# Access Compliance Report

## Public Rights-of-Way

Intersection ID: 6578	Main Street: CAPPS_HILL_DR	Cross Street: CAPPS_HILL_MINE_RD	Location: SW
ADA ID: C100B6AC7CC2	Ramp Type: BlendTrans1	Initial Pass/Fail: Fail	Overall Compliance: No
		Severity Score: 25

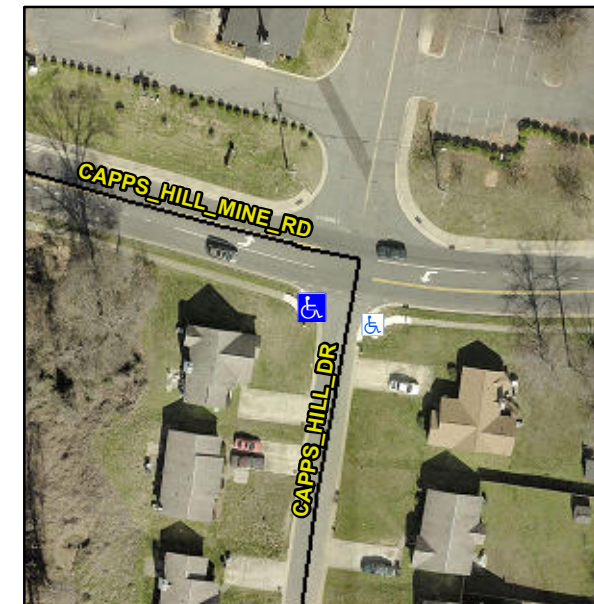
**Not Found, R304.5.3**

Compliance	Description	Data	Compliance	Description	Data
N/A	Ramp Length (in)	96.0	Yes	BlendTrans Slope (%)	4.7
Yes	Ramp Width (in)	59.0	No	BlendTrans XSlope (%)	8.0
N/A	Flare Type LT	N/A	N/A	Flare Type RT	N/A
N/A	Flare Slope LT (%)	N/A	N/A	Flare Slope RT (%)	N/A
N/A	Flare Traversable LT?	N/A	N/A	Flare Traversable RT?	N/A
N/A	Landing Length (in)	N/A	N/A	DWS Provided?	N/A
N/A	Landing Width (in)	N/A	N/A	DWS Contrast?	N/A
N/A	Landing Slope (%)	N/A	N/A	DWS Length (in)	N/A
N/A	Landing X Slope (%)	N/A	N/A	DWS Full Width?	N/A
N/A	Landing Curb? (Y/N)	N/A	N/A	DWS Offset (in)	N/A
N/A	Shared Landing?	N/A			
N/A	Gutter Ponding?	N/A	N/A	Gutter Slope (%)	N/A
N/A	Gutter Lip Ht (in)	N/A	N/A	Gutter X Slope (%)	N/A
N/A	Painted X Walk1?	No	N/A	Painted X Walk2?	N/A
	X Walk 1 Direction	To E		X Walk 2 Direction	N/A
	X Walk 1 Width (in)	N/A		X Walk 2 Width (in)	N/A
	X Walk 1 Slope (%)	9.9		X Walk 2 Slope (%)	N/A
	X Walk 1 X Slope (%)	0.1		X Walk 2 X Slope (%)	N/A

N/A	Ramp inside XWalk1?	N/A	N/A	Ramp inside XWalk2?	N/A
	Road Slope (%)	0.1		Clear Space?	N/A
	Road X Slope (%)	9.9	N/A	Clear Space to XWalk (in)	N/A
N/A	Any Obstructions?	N/A	N/A	Storm Grate/Utility Hazard?	N/A
	Obstruction Type			Storm Grate/Utility Type	
		N/A			N/A
			Yes	Surface Condition? (G/P)	Good
			No	Curb Slope (%)	13.0

**Remove & Replace Curb Ramp With Two New Directional Ramps or Equivalent.**
